SUBJECT: DOCKET ITEM NOS. 21 AND 22 – CASE BAR2001-120 AND CASE
BAR2001-121 – 105 QUAY STREET BAR APPEALS

Docket Item #
BAR CASE #2001-0120 & 2001-0121

ISSUE: Appeal of a decision of the Board of Architectural Review, Old and Historic Alexandria District, denying a dormer and associated demolition

LOCATION: 105 Quay Street

1 SOUTH ELEVATION
1/4" = 1'-0"

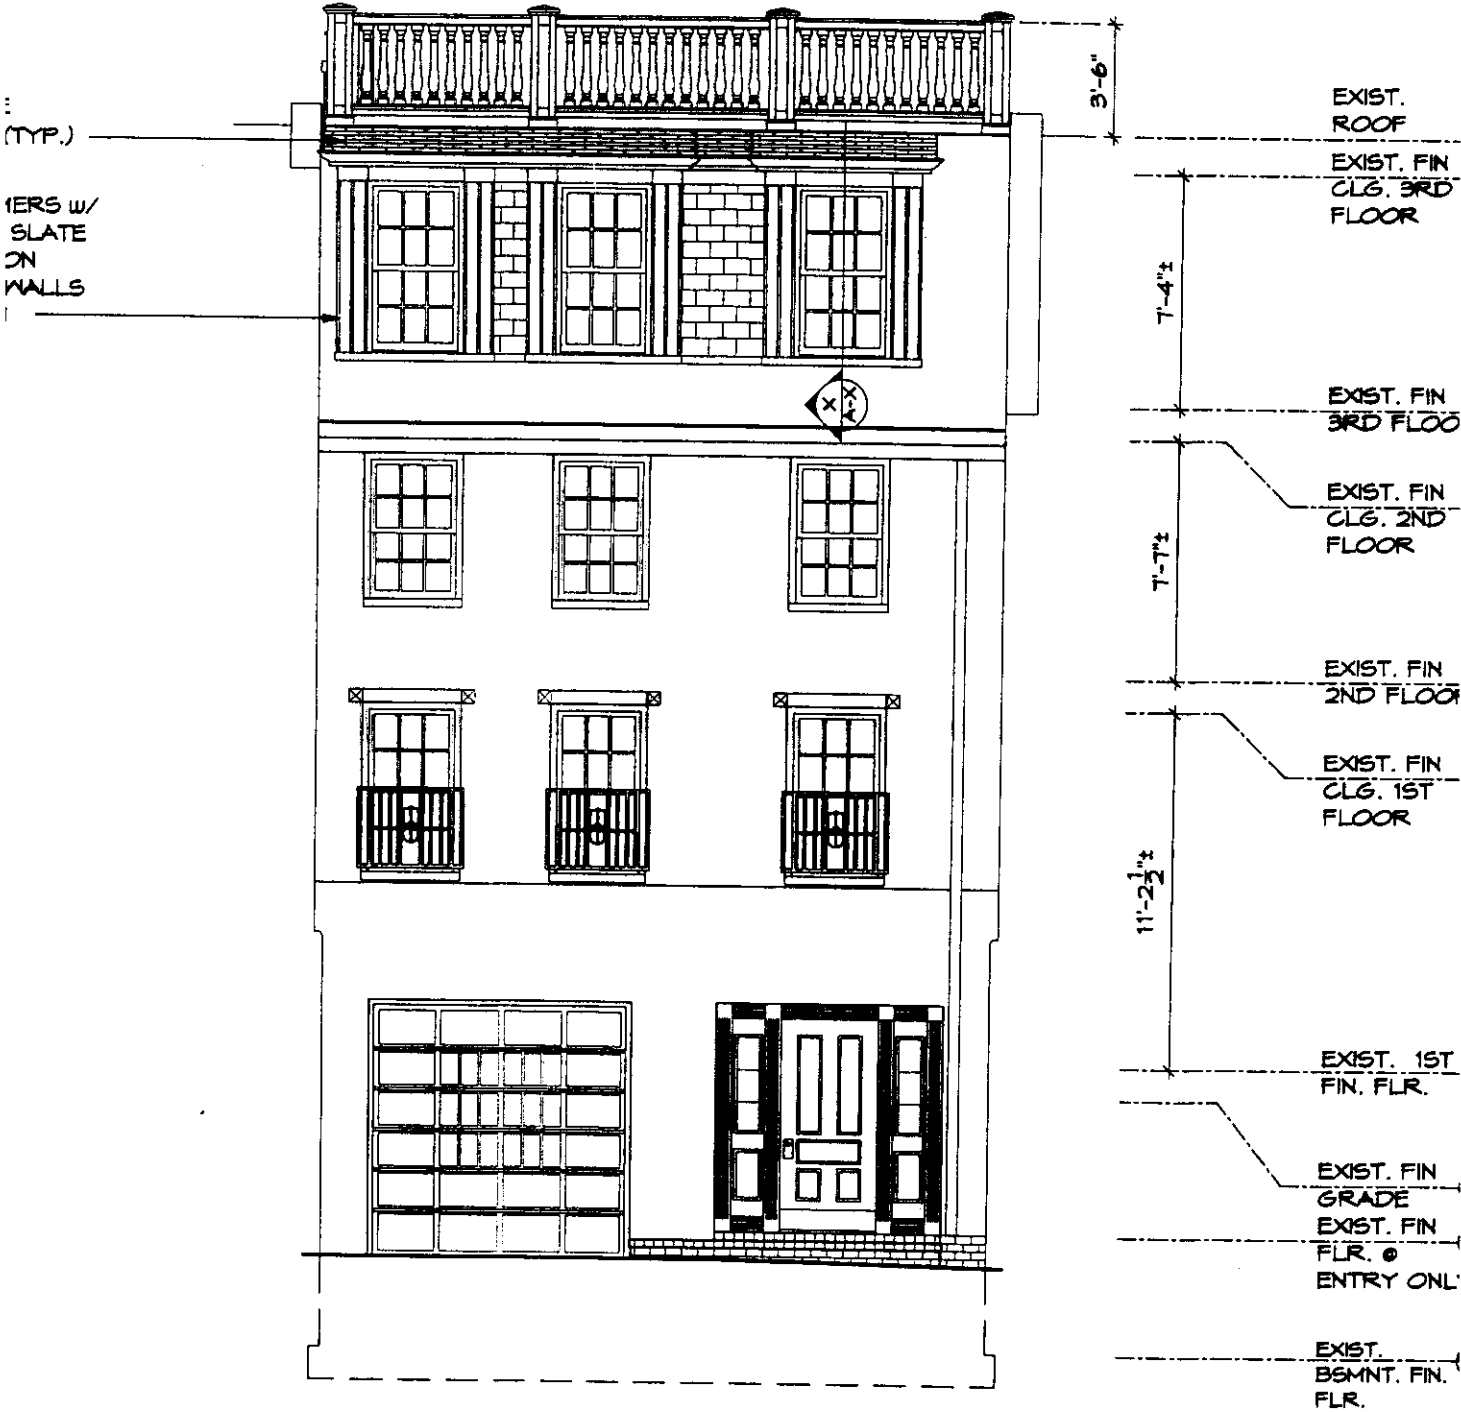
Mr. Wilbor said that each block has its own character and that Quay Street was a pristine block without any dormers. He said that the Board had denied this application previously. He said OTCA had made the point before Council on the appeal last year that dormers had been tried on some of the townhouses in this development and that dormers do not work on these townhouses. He said that everyone who lives in the historic district is held hostage to quality control through the Board of Architectural Review. He also said that the blocks in this development contain their own characteristics and Quay Street has not been flawed by any obvious alterations to the rooflines and that OTCA recommends that the block be maintained because it is the last block that is intact. He said that the business of the Board is architecture not politics and that the decision by City Council on appeal had been based on politics. He said that the dormers did not work last year and they are not going to work this year. He said that the applicant could put a dormer on the rear where it is not visible from the street. Finally, he said OTCA asks the Board to stand its ground and maintain quality control in the historic district and deny this application for dormers facing on Quay Street.

Ms. Neihardt said that this was a difficult issue. She cited the dormer at 125 Queen Street which the Board had approved and which was too large. She said that she had not changed her position from last year and believed that the dormer was not appropriate and that she would not support the dormers in this application.

Mr. Wheeler said he agreed with Ms. Neihardt and that he was opposed to the dormer which he said was overscaled and massively out of scale with the house and dominates the upper 30% of the Mansard roof of the house. He then made a motion to deny the application.
